**STAFF REPORT - TOWN OF NORTH CASTLE PLANNING DEPARTMENT**

October 31, 2022

APPLICATION NUMBER - NAME  
#18-004 – Eagle Ridge – Preliminary Subdivision  
Plat Approval | Site Plan, Tree Removal Permit  
and Steep Slope Permit Approvals

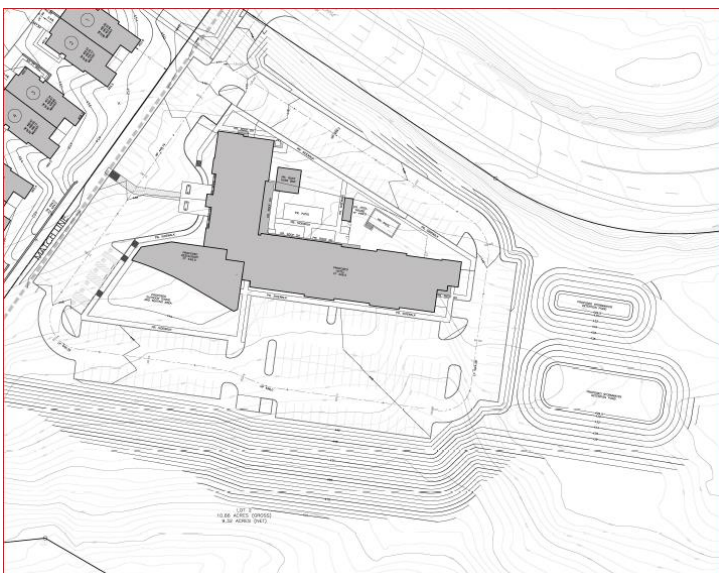
6. The site plan shall be revised to depict the location of the oak-tulip forest.

The site plan should attempt to save this forest to the maximum extent practicable.
